UNITED STATES PATENT AND TRADEMARK OFFICE

Office Action Summary	Application No. 09/831,899	Applicant(s) REYNAUD, GERARD	
	Examiner Darwin P. Erez	Art Unit 3731

DETAILED ACTION

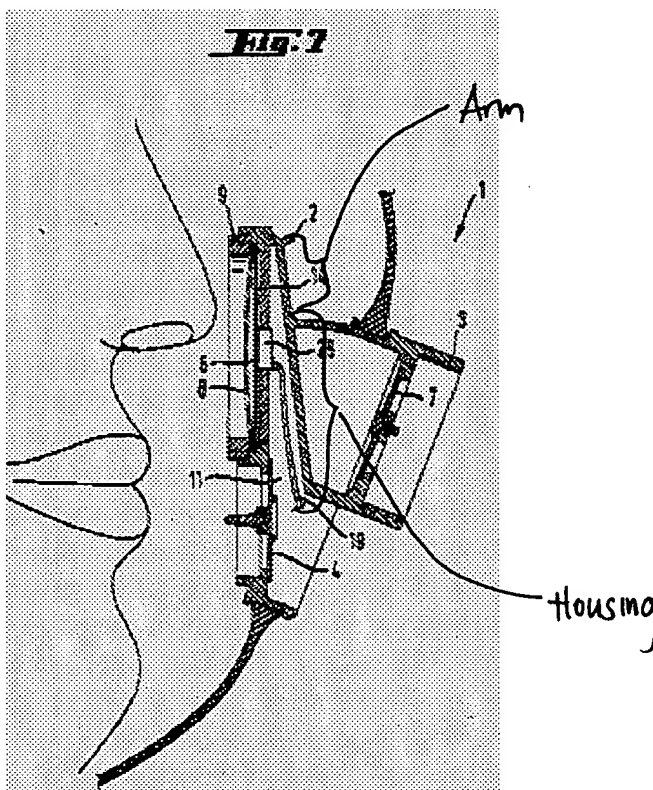
(claim 17) Bolnberger teaches a mask having a flexible cap **1**; an exhalation port **4** pierced through the cap; a housing on an inner surface of the flexible cap (see attached Fig. 1); first microphone capsule **13** positioned above the exhalation port; a tubular mouth-piece **9, 14** extending from a first distal end disposed adjacent the flexible cap to a second distal end projecting away from the flexible cap, the first microphone capsule mounted at the first distal end of the tubular mouthpiece (the part of **9** closes to the mouth-piece), the second distal end of the mouthpiece disposed away from the microphone capsule and defining aperture turned away from the flexible cap (see Fig. 3); an arm extending from the housing and supporting the tubular mouth piece at the first distal end adjacent the first microphone capsule (see attached Fig. 1). Bolnberger is silent with regards to the mouthpiece being a conical tubular mouthpiece.

As noted in the rejection above, Bolnberger teaches a housing and an arm extending from the housing to support the tubular mouthpiece. The attached Fig. 1 better illustrates what the examiner considers as the arm. It should be noted that the limitation "arm" is not interpreted as a completely separate structure, i.e., an arm can be anything that extends from a surface.
